ADD SECURE

IRIS-4 Firmware 4.9.0

This document details changes from firmware Version 4.6.2 to Version 4.9.0. for IRIS-4 and Edge products.

2.3 Modified Support for Vanderbilt SPC Panels via Ethernet

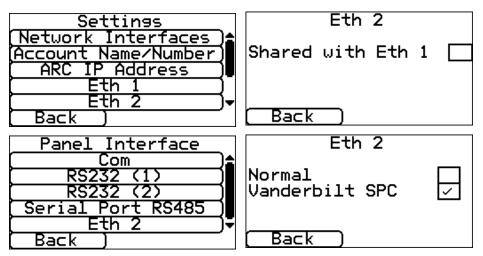
For some time, IRIS 4xx terminals, which have two Ethernet interfaces, have been capable of supporting connections from Vanderbilt (formerly Siemens) SPC panels via Ethernet and forwarding alarms from the panel to ARCs equipped with an IRIS Secure Apps system. This function has been extended to the new IRIS-4 6xxD products as well.

There has been a modification to the way this works, driven by the fact that Microsofts' Dialup Networking function is no longer supported in Windows 10 in the same was as it was on earlier Windows versions. This means that remote access to the panel from Siemens SPC Pro software is no longer possible using the combination of Dial-up Networking and the IRIS Remote Service App. Therefore, an alternative way of supporting SPC Pro connection via AddSecure 's Link service has been provided. The same can also be done with any SIM card that provides remote connection from an external IP source.

The ways that this affects the installation are as follows:

- 1) The IRIS terminal now includes a DHCP server on the second Ethernet interface so the panel should be set to use DHCP, rather than a fixed IP address.

- 2) The monitoring centre IP address (the EDP IP address) set in the panel must be the IP Gateway address given to the panel by the IRIS DHCP server. This IP address can be obtained from the panel (e.g. via the keypad).

- 3) For remote access to the panel using SPC Pro, the destination IP address for the panel must be the IP address associated with the SIM card fitted to the terminal. Depending on the SIM card provider this may require a connection between the PC running SPC Pro to the SIM card providers own data network. In the case of AddSecure's Link service this uses a connection using OpenVPN with a Certificate provided by AddSecure.

- 4) The IP Address and Remote Access settings have been removed from the terminal's touch screen menu as they are no longer required. When selecting Siemens mode, the option 'Shared with Eth 1' is automatically deselected.

4.5.1 Operation with Galaxy Flex alarm panels

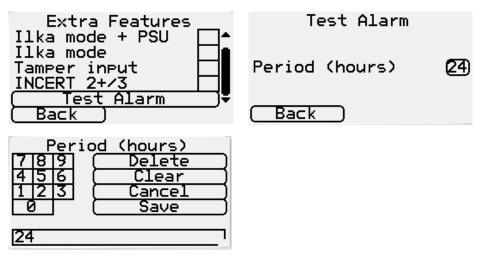
It has been identified that when an IRIS terminal is connected to a Galaxy Flex alarm panel via the RS485 bus, some events can cause it to generate a Tamper alarm within the panel. This release prevents this happening.
